LOCAL HISTORIC DISTRICT: Plaza Midwood

PROPERTY ADDRESS: 1617 Thomas Avenue

SUMMARY OF REQUEST: Parking pad

Charlotte Historic District Commission - Case 2016-138
HISTORIC DISTRICT: PLAZA MIDWOOD

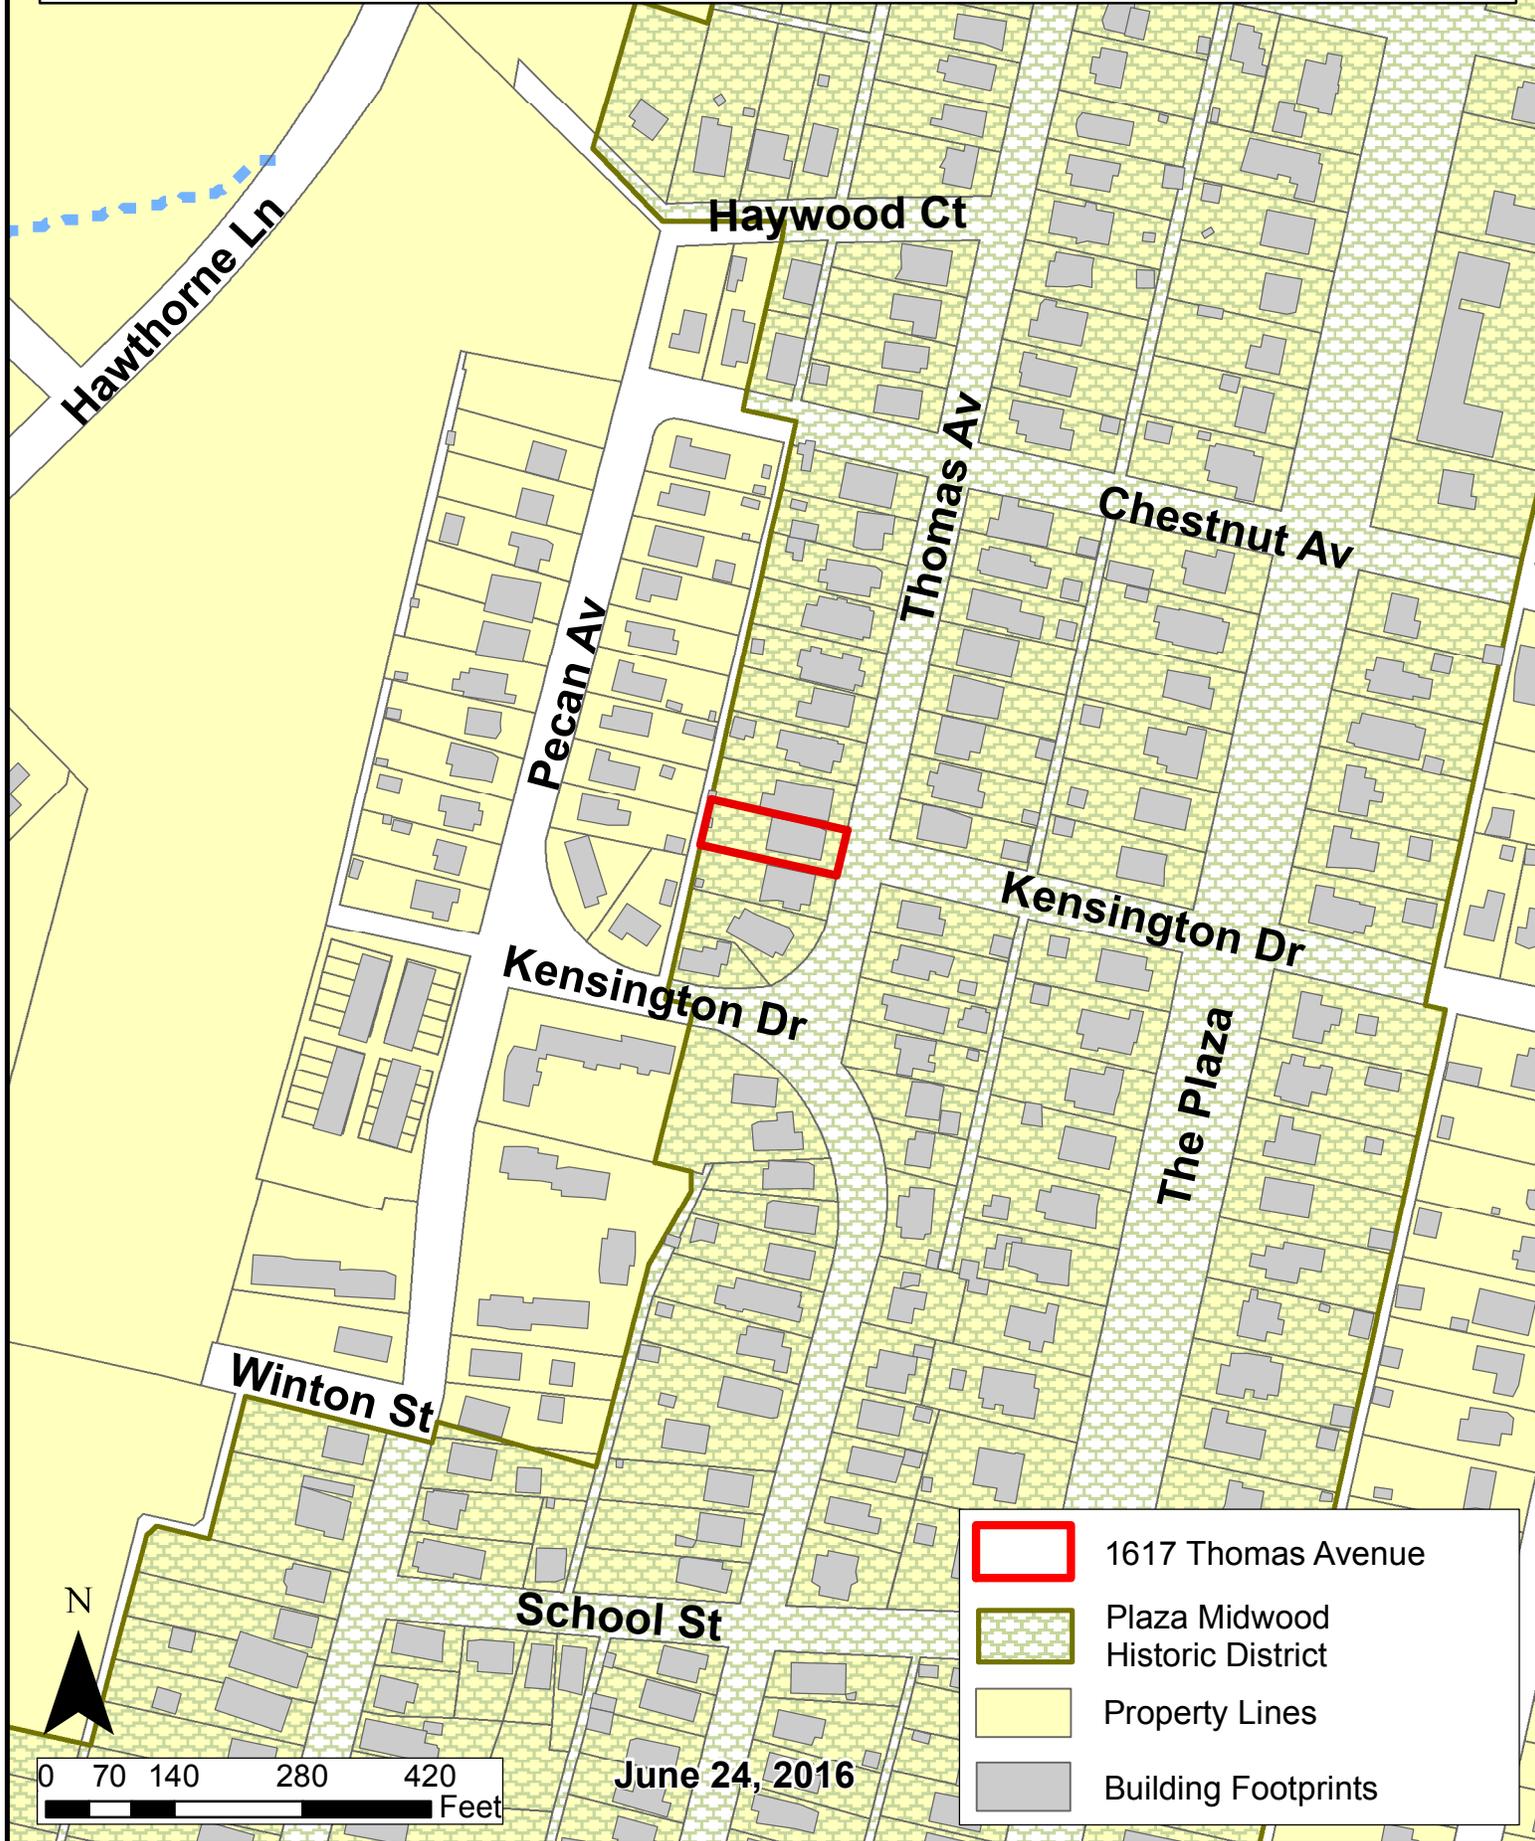
The property owner constructed a concrete parking pad in the front yard. The owner is requesting an exception to allow the parking pad to remain.

The Commission will determine if an exception should be granted for the parking pad in the front yard.
